October 24, 2023

Subject: Trumark at Kassis (PLND-0623-0073) Consistency Review per SB 330

DESIGN REVIEW LANDSCAPE PLAN CHECK
City of Rancho Cordova

Project: CE455_Trumark at Kassis TSM, DR PLND-0623-0073 - Rancho Cordova, California
Reviewed by: Michael Engle, RCLA 4672
Comments to: Arlene Granadosin-Jones, Senior Planner
City of Rancho Cordova
2729 Prospect Park Dr.
Rancho Cordova CA 95670
916-851-8846

Sheet 5

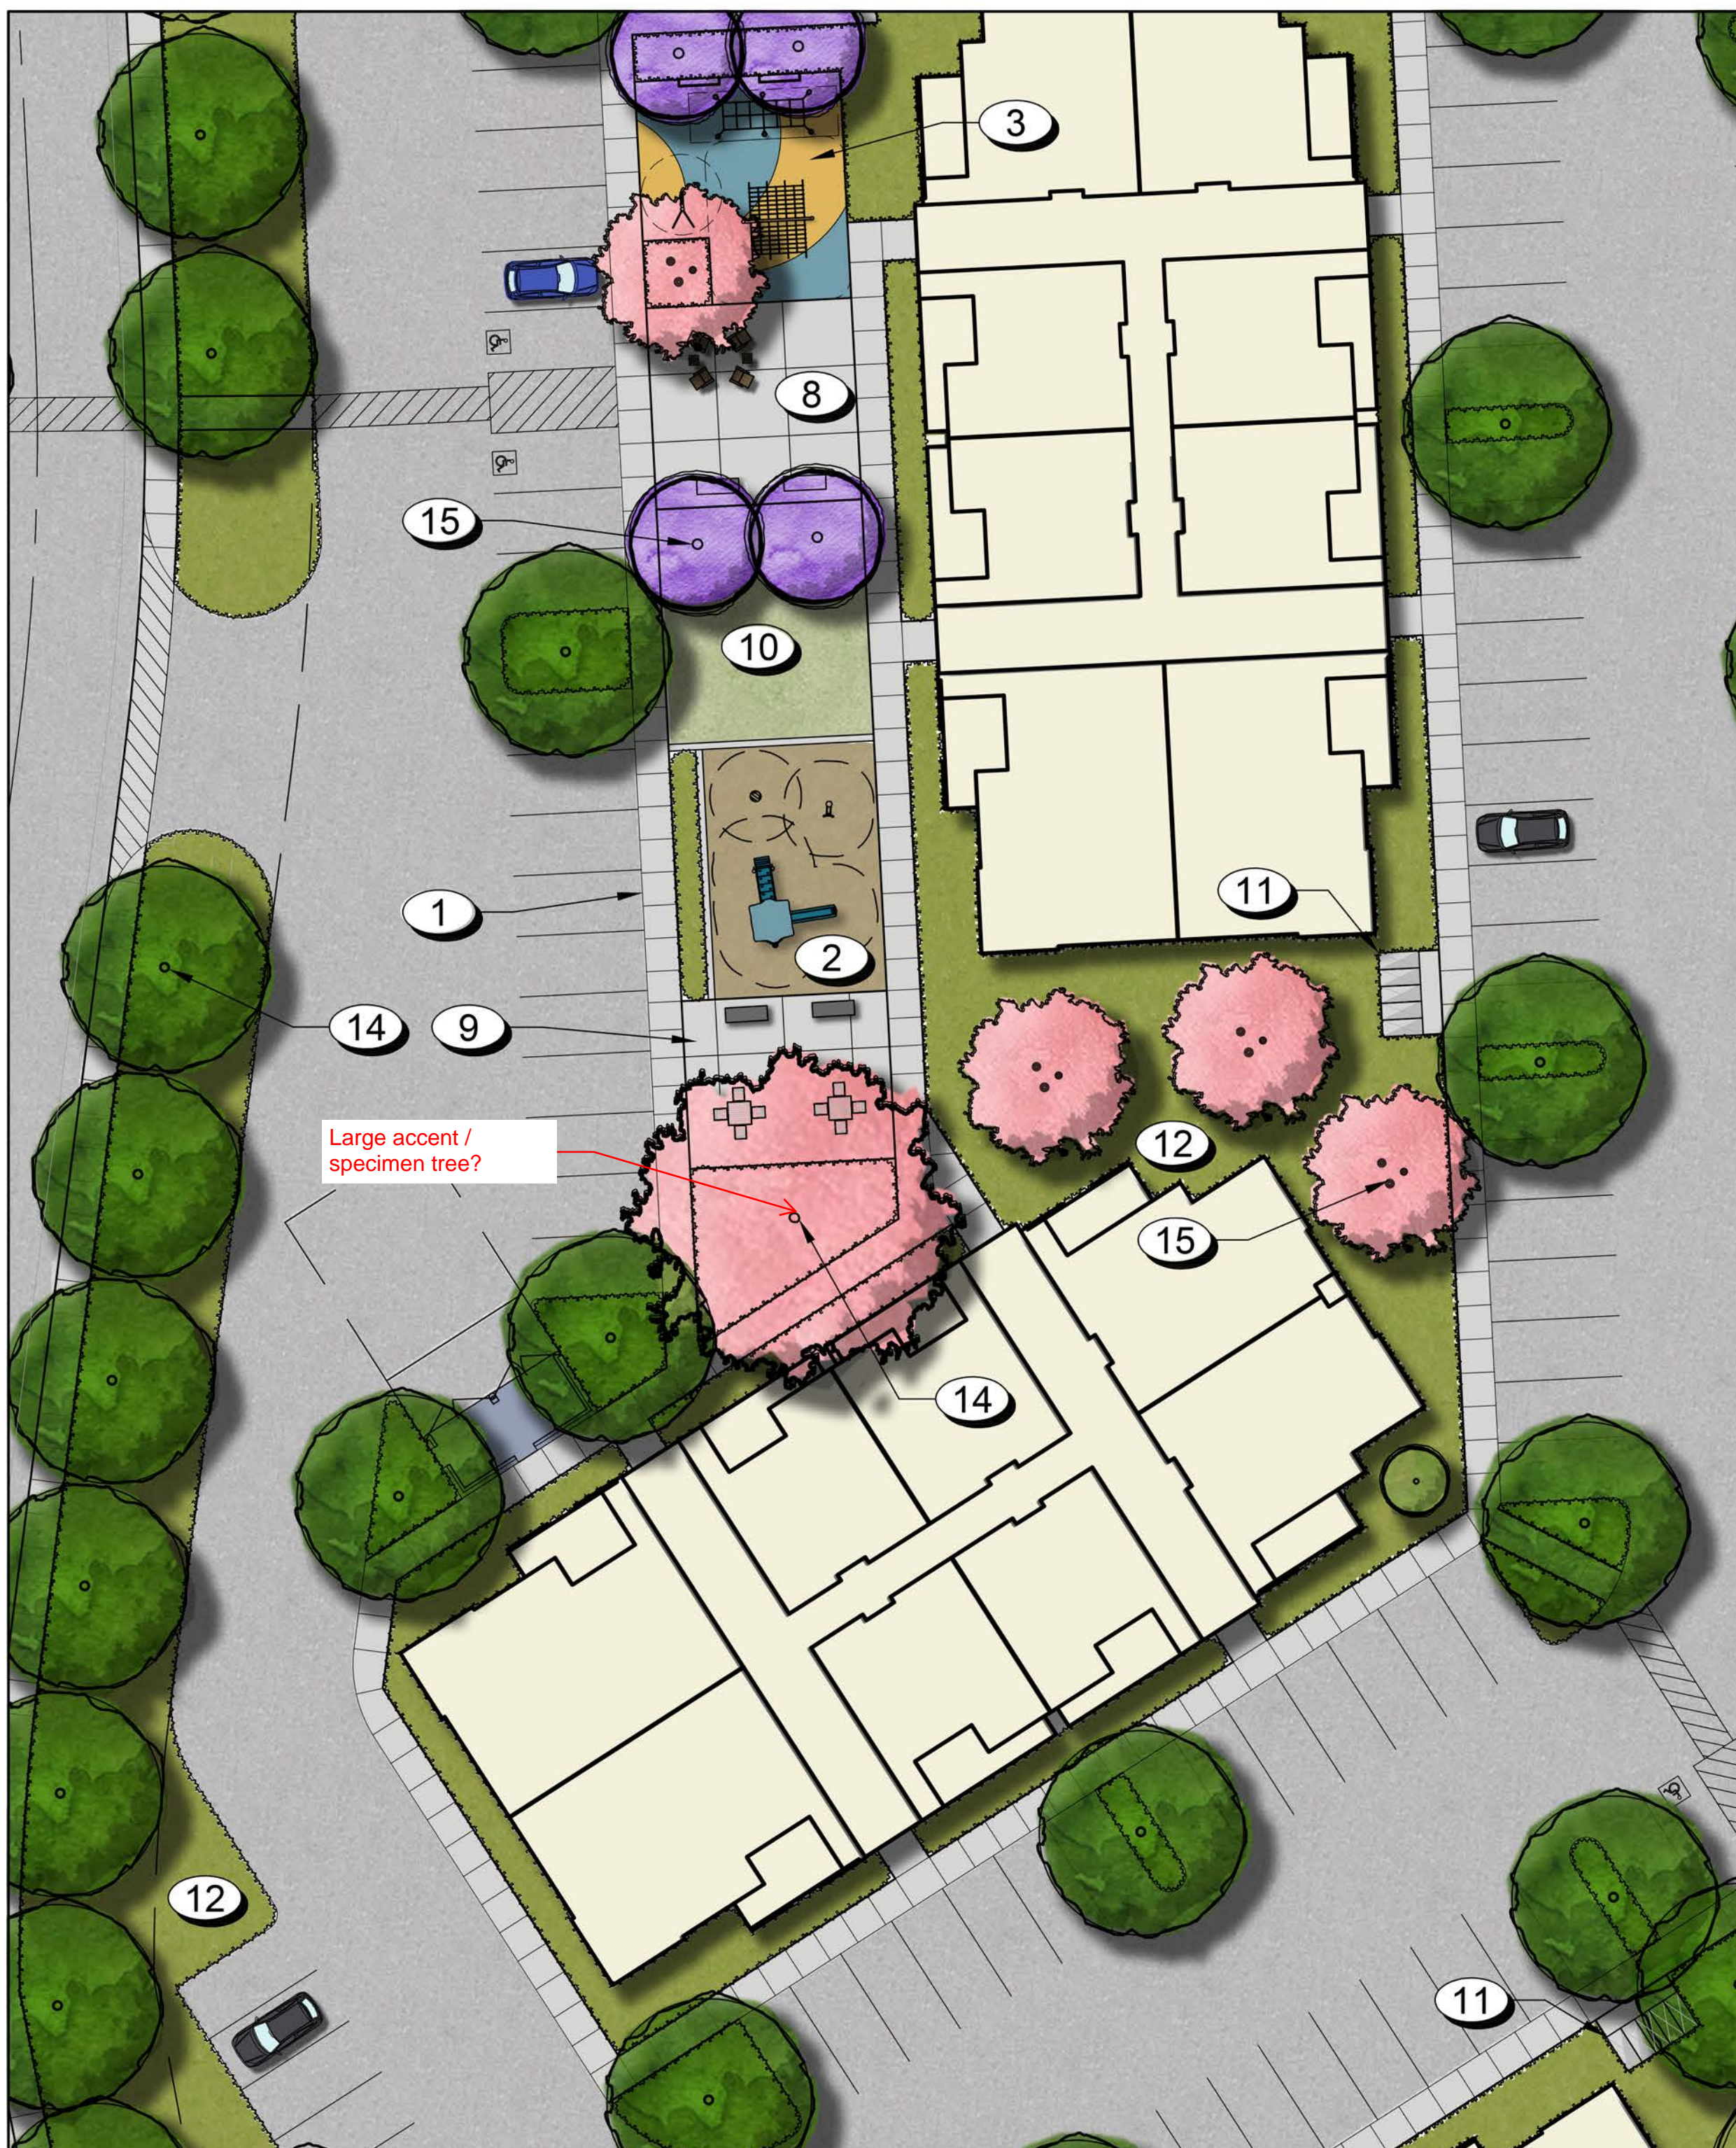
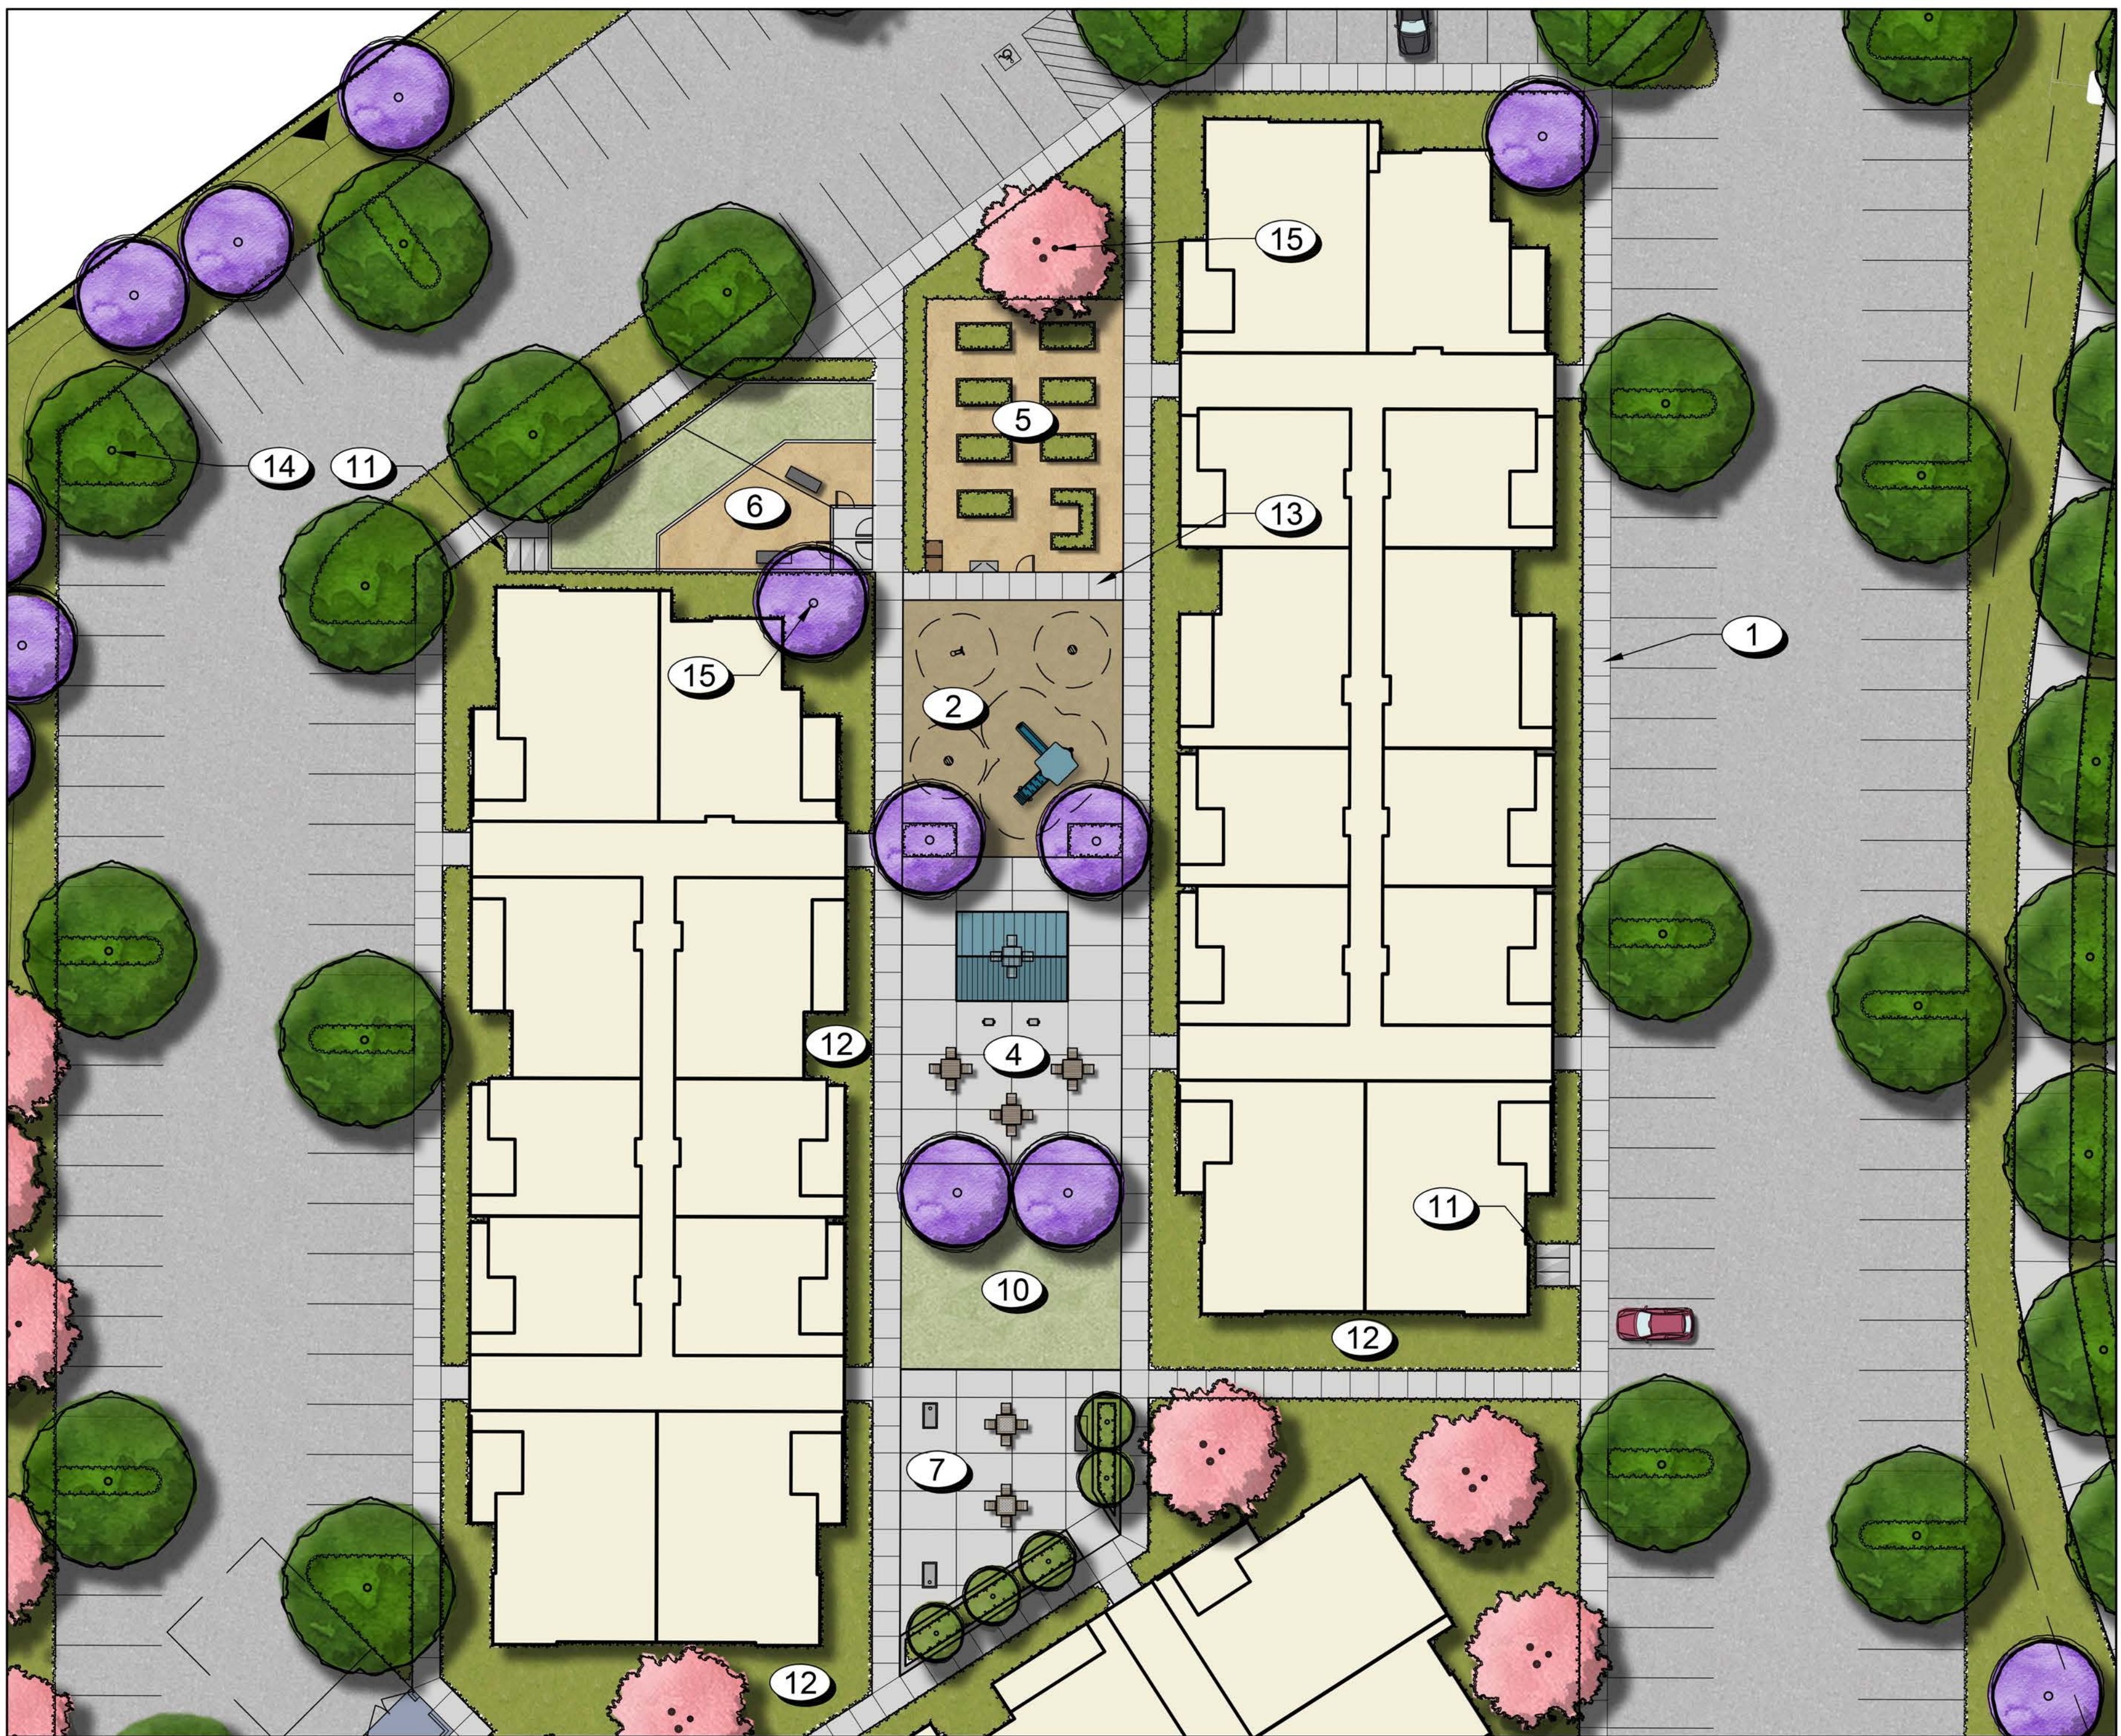
3. Sheet 5: Multi-Family Housing – Common Areas
 - a. There is one large tree that appears to be a specimen tree. Please clarify.
